## Technical Review Board Memorandum

**Date:** January 31, 2017

**Issue:** **Retrofit of School Doors for Potential Door Jamming  
in a Seismic Event (For Single Doors)**

**Figure 1: Strike Plate Slot Details  
for Potential Door Jamming  
of School Single Doors**

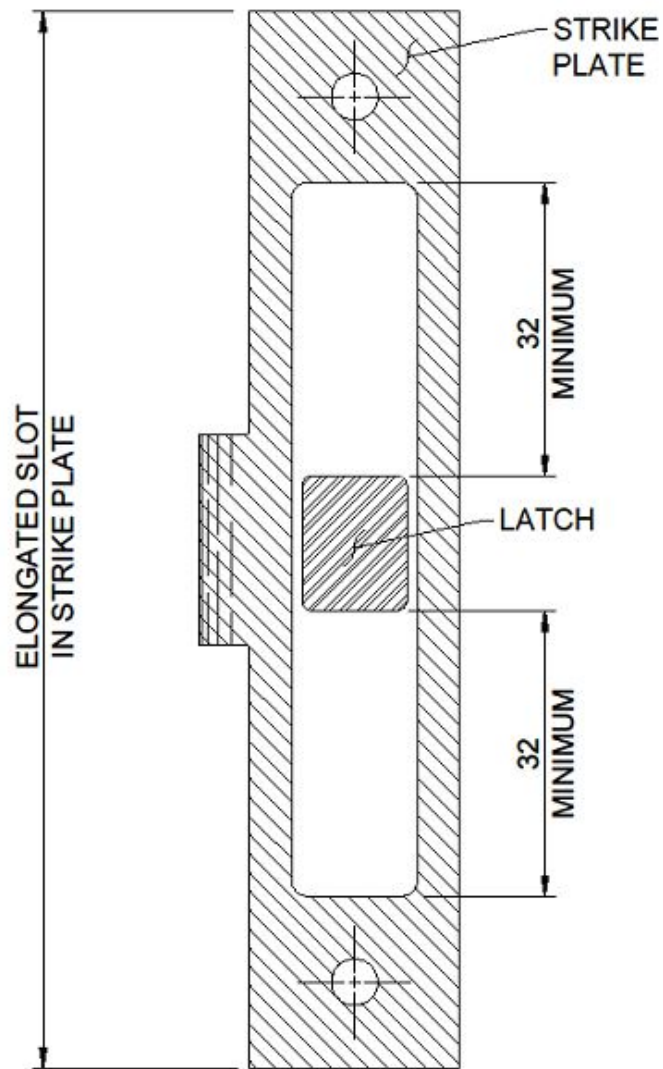
The proposed door strike plate modification is illustrated in Figure 1. Features of these retrofit details are as follows:

- slot in the strike plate is elongated vertically such that the slot clearance above and below the latch is not less than 32 mm;
- Figure 1 modification only applies to single doors;
- no trimming of the top or bottom of the door is required.

It is recommended that all school single doors, whether wood or steel doors, be modified to conform to the detail given in Figure 1 to reduce the potential for door jamming in a seismic event. This door modification requirement applies to all single doors in the first storey and to all single doors in the storeys above the first storey.
